SIL 09-EP-16
March, 2016
Page 1 of 6

SUBJECT: Energy Storage System 3 (ESS 3) Release Notification

MODELS AFFECTED: H 40/50 EP™ Transmissions

Figure 1. Energy Storage System (ESS)

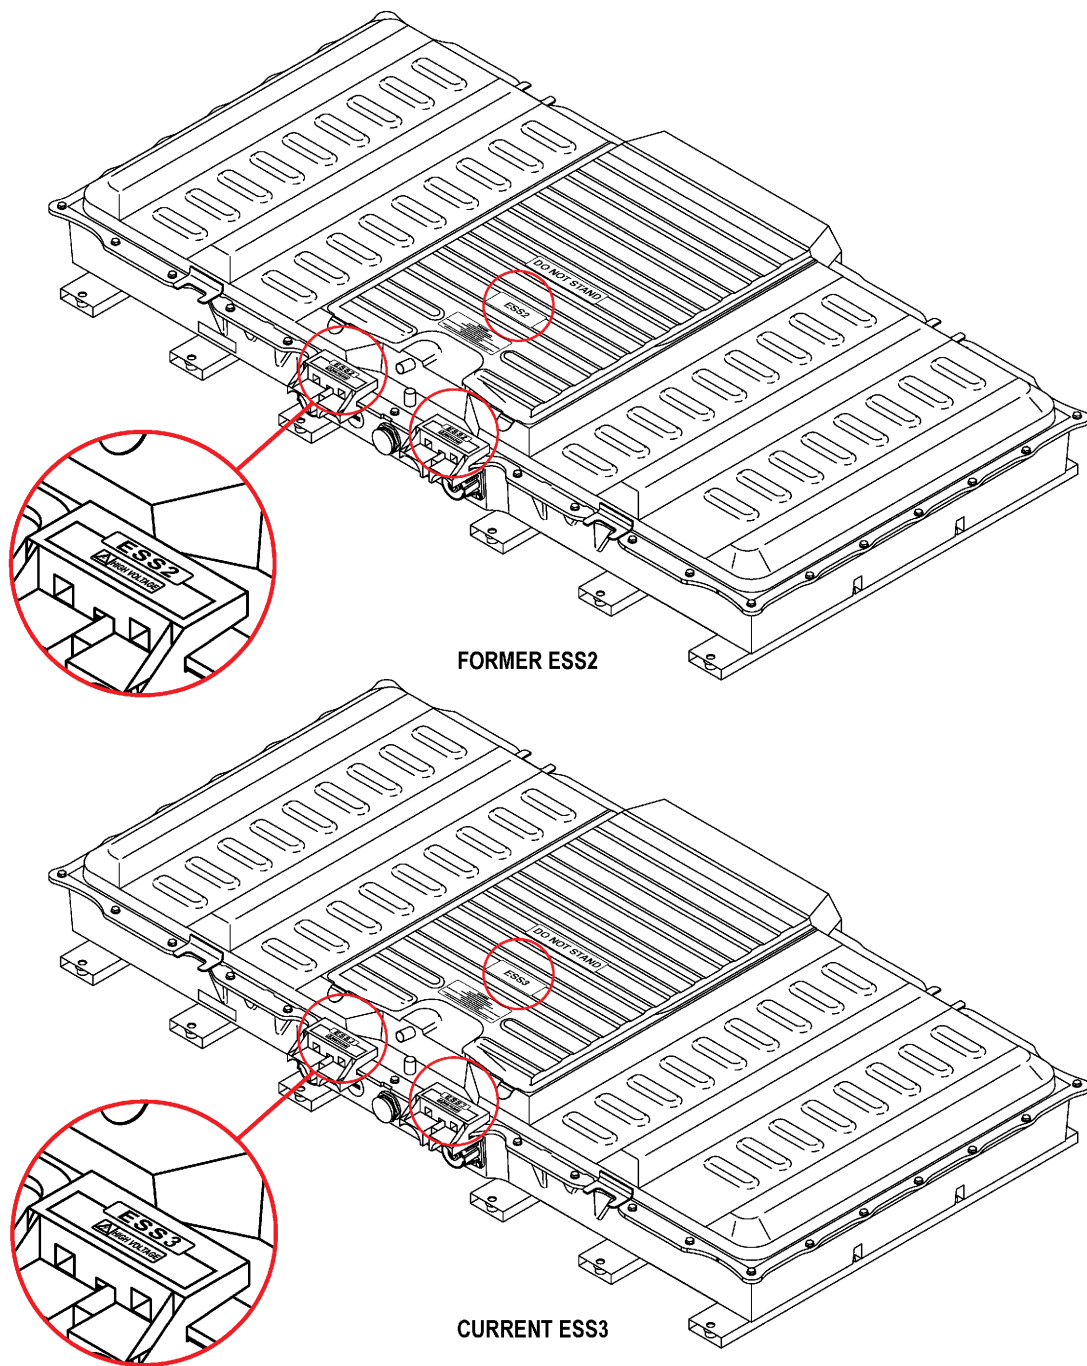
The differences between ESS2 and ESS3 are internal with the exception of some identifying stickers on the ESS cover and HVIL covers (refer to Figure 1). A new System Identification Number (SID) must be Re-flashed when an ESS2 is replaced with an ESS3. The connectors (high voltage and low voltage), pins, mounting points, and external dimensions are identical between the ESS2 and ESS3 making them fully interchangeable assemblies.

Figure 3. TCM Assembly Number

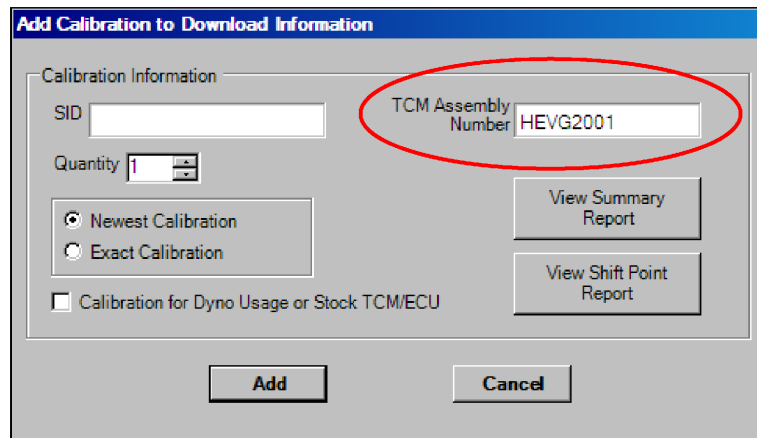
When an ESS1 or ESS2 is replaced with an ESS3, the SID must be updated so the 4th digit matches the new hardware configuration of the system. The rest of the TCM Assembly Number portion of the SID should stay the same, but all other digits may be different. For this reason, the new SID should be downloaded as a TCM Assembly Number rather than a SID (refer to [Figure 3](#)). To download any SID by TCM Assembly Number, add a “HEV” prefix to the TCM Assembly Number portion of the SID. If changing a vehicle’s hardware configuration, change the second digit of the TCM Assembly Number based on Table 1.

Figure 7.
ESS3 BCIM P/N 29558054 With E30 Software

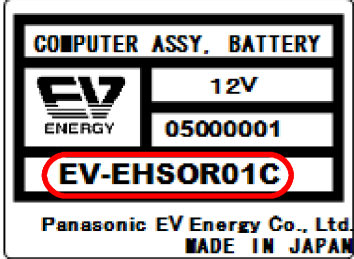
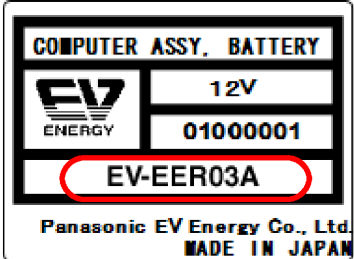
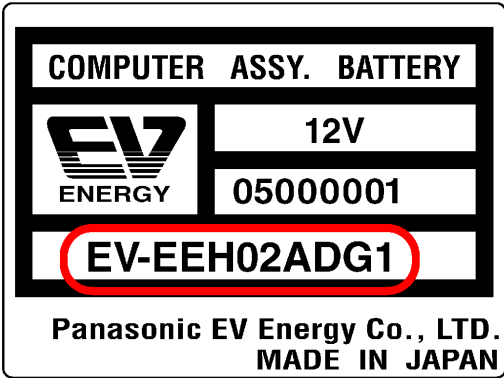
The parts listed in Table 2 are new for ESS3 and are not interchangeable with the former ESS2 parts. Figures 6 and 7 illustrate BCIM differences.

NOTE: Although the ESS2 and ESS3 BCIMs look identical, they have different software. It is important to install the correct BCIM during a repair. Failure to do so will set an active 76-61 Battery Subpack Software ID code and shut down the vehicle's high voltage system. The only way to correct this scenario is to install the correct BCIM. As seen in Table 3, BCIMs can be identified by either their Allison or Panasonic P/Ns prior to installation. Refer to Table 3 and the interchangeability section of this SIL to identify whether you are working on an ESS2 or an ESS3. The software levels of ESS2 and ESS3 are subject to revision, but the middle digit of the software will always remain the same: "2" for ESS2 and "3" for ESS3.
